### **Remarks/Arguments**

The Applicants would like to thank the Examiner for the courtesy extended during the telephone interview of August 17, 2004. As discussed at the interview, the present invention pertains to a system broadcasting programs that include a main audio track and a second audio track on the so-called SAP channel. The SAP channel can carry a voice track in a different language (Spanish, Italian, etc. ) or it can carry other type of audio tracks, such as DVS (descriptor video service) or other English audio channel. The invention further covers TV receivers and their circuitry receiving this type of broadcast. As defined in independent claims 1, 8, 15, and 20, an important feature of the invention is that, incorporated into the broadcast signal, there is an SAP indication signal. This latter signal consists of information that defines the content of the SAP channel, i.e., whether it contains a track in another language, DVS , etc. The receiver includes a selector that selects whether the main audio track or the on the SAP channel or sound track is to be the active track based on the SAP indication signal.

FIG. 1A PRIOR ART  
 Sketch A

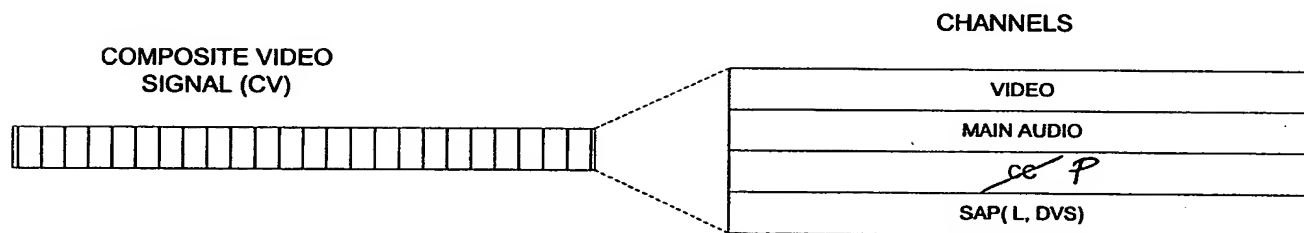
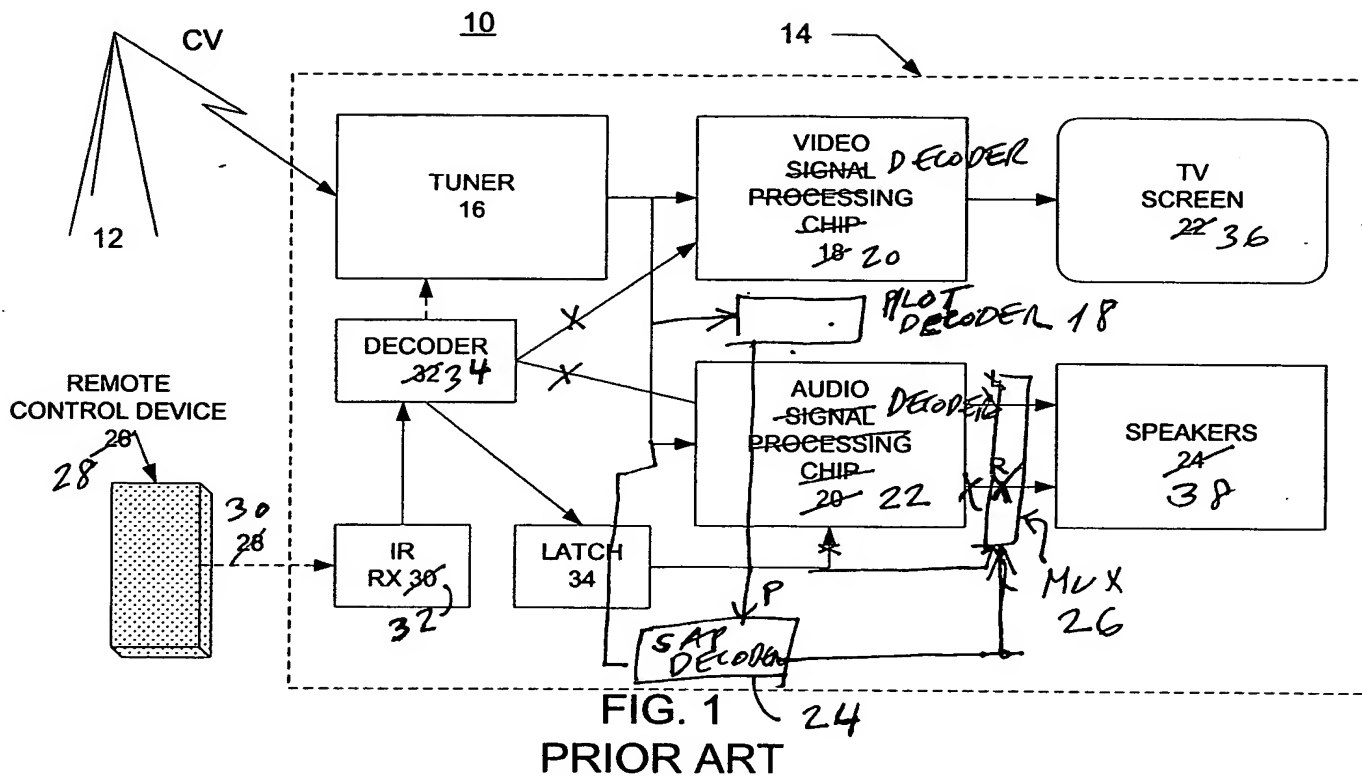
During the review of the subject application, it was discovered that Figs. 3 and 4 were inadvertently submitted. These drawings are not described in the specification and therefore the Applicants respectfully request that these drawings be withdrawn. In addition, it has been discovered that in Figs. 1 and 2, the pilot signal detector 18 has been omitted and that in Figs. 1A and 2A the pilot signal P and the modified pilot signal MP has been inadvertently replaced by signal CC. Enclosed are replacement sheets with Figs. 1, 1A, 2 and 2A corrected to conform with the specification. Also enclosed are Sketches A, B, and C indicating the changes made to the original figures.
